# HMMH

## TECHNICAL MEMORANDUM

**Subject:** Review of SFO Proposed Noise Monitoring System Thresholds – Phase 2

**Reference:** HMMH Project Number 312310

Figure 1: 65 CNEL Contour as Reported in the SFO Quarterly Noise Report for the 4<sup>th</sup> Quarter 2019

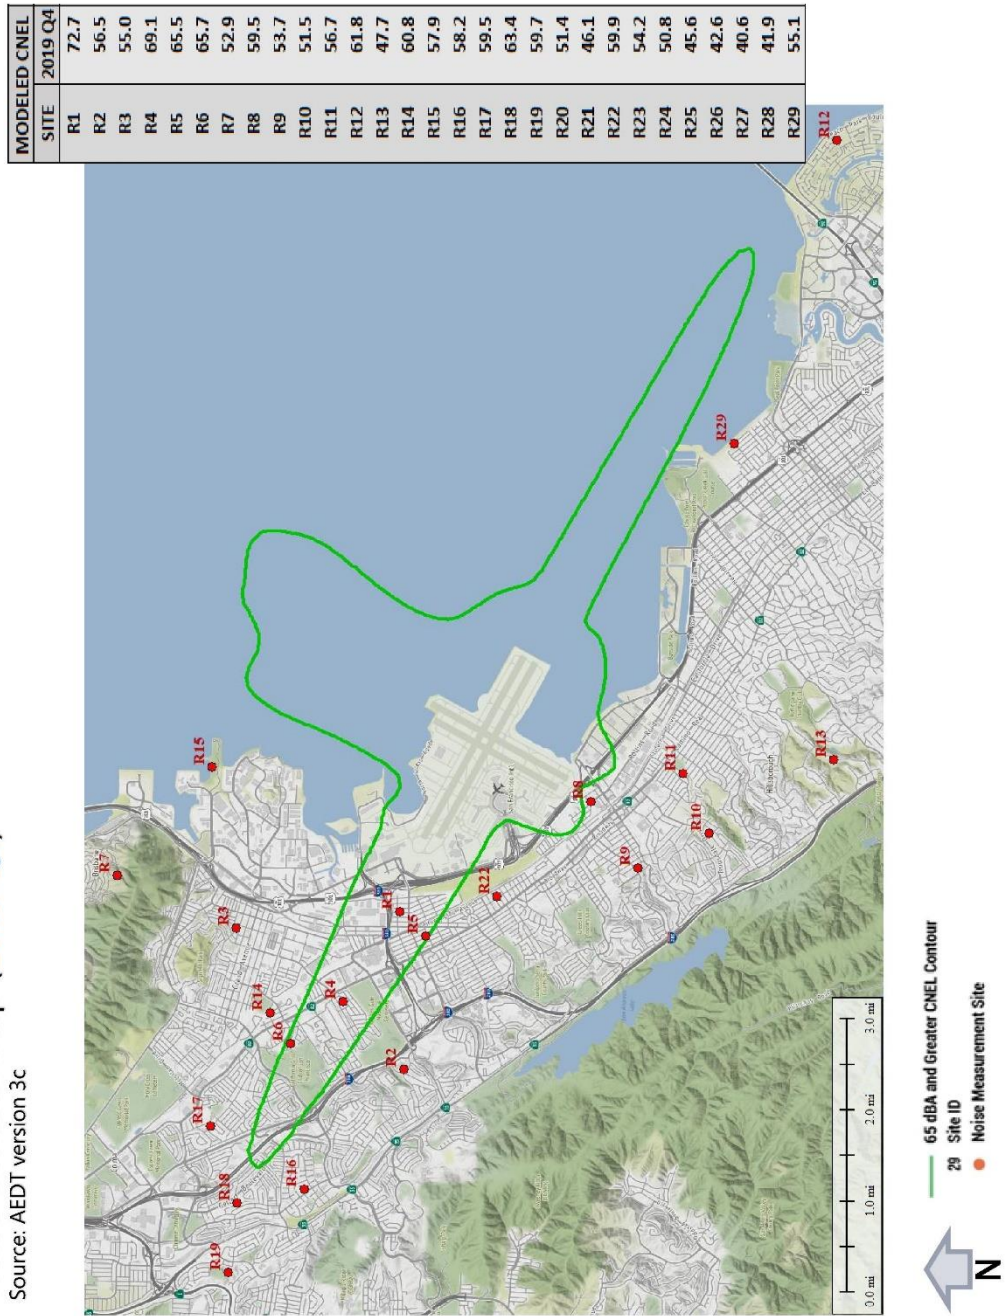
To meet the Title 21 requirement to use noise monitoring locations “...to facilitate locating the maximum extent (closure points) of the noise impact boundary when the contour extremities encompass incompatible land uses”, HMMH reviewed the two quarterly noise report 65 CNEL contours in Figures 1 and 2.

Given the change in size of the SFO 65 CNEL contour due to the pandemic, the area most affected by the change in the number of aircraft operations with incompatible land uses is to the west from the heavy and international flights departing SFO to the west, also known as “Gap Departures”. Therefore, HMMH evaluated the NMT locations out the gap to account for the recently realized potential variation in the size of the 65 CNEL contour lobe to the west. The SFO NMT sites required to locate the maximum extent of the 65 CNEL contour lobe to the west include:

- Sites 1 and 4 during times of extremely low volume of aircraft operations (2020)
- Site 18 during a recent high volume of aircraft operations (2019)
- Sites 4 and/or 6 during times of aircraft operations between the low and high volumes of operations
- Site 19 in case SFO experiences higher volumes of aircraft operations than 2019 in the near future

Therefore, in our opinion, the SFO monitoring plan, to be approved by Caltrans in accordance with Title 21, should include up to the following eight (8) NMT sites to locate the maximum extent of the 65 CNEL contour in proximity to incompatible land uses:

- 1 San Bruno
- 4 South San Francisco
- 6 South San Francisco
- 8 Millbrae
- 15 South San Francisco
- 12 Foster City
- 18 Daly City
- 19 Pacifica
